Product Bulletin

Turbine Series Bracket Change

Bulletin Number 7593 17 April 2003

New One-Piece Bracket
(RK 15378)

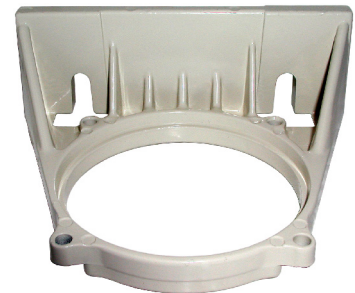
Racor currently offers two different bracket styles for our 500FG Turbine Series and 500MA Marine Turbine Series fuel filter/water separator assemblies: a one-piece die-cast aluminum bracket and a three-piece steel bracket. These brackets styles will be phased out over the next several months and replaced with our new one-piece steel bracket. Replacement kits for current bracket styles will be available for a limited time; part numbers are RK15090 (one-piece) and RK15300 (three-piece).

- Simple and robust steel strap.
- Uses a single carriage bolt for installation.
- Lighter and easier to install than current styles.
- Mounting flexibility – full 360° rotation available during installation to line up fuel ports and attach fuel lines.
- Generous horizontal mounting slots that can accommodate mounting positions used by other brackets: from 3.60" (9.1 cm) to 5.30" (13.5 cm).
- Been in production on our 75500FGX Turbine Series and 75500MAX Marine Turbine Series assemblies since 1993.
- Integral part of our Underwriter Laboratories (UL) listed marine assemblies.

Mounting comparison with bracket centerline at the same location.

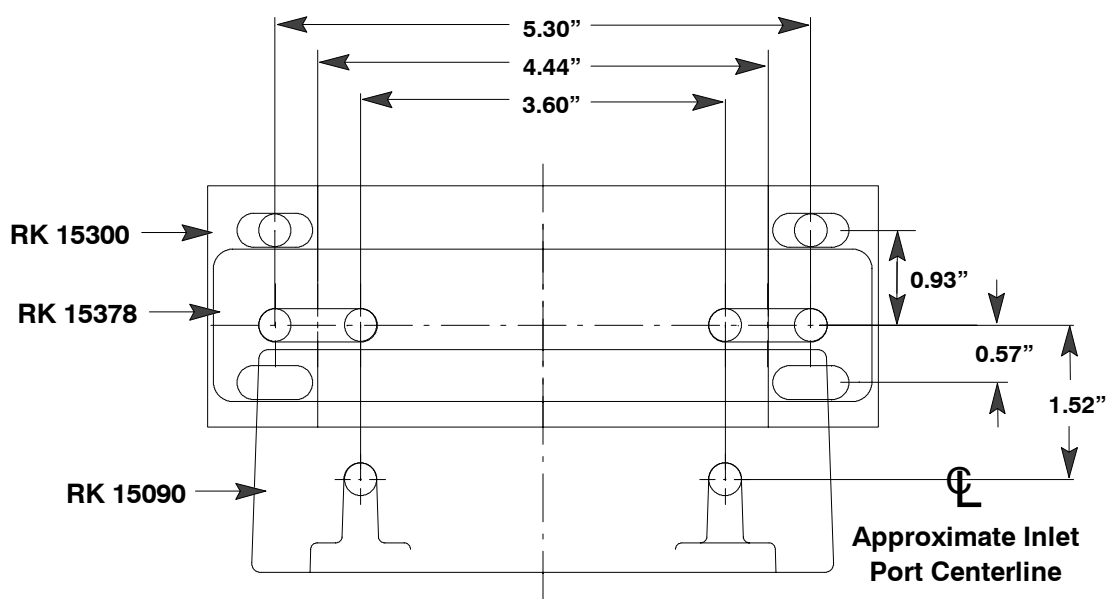
See other side of this bulletin for additional mounting information.
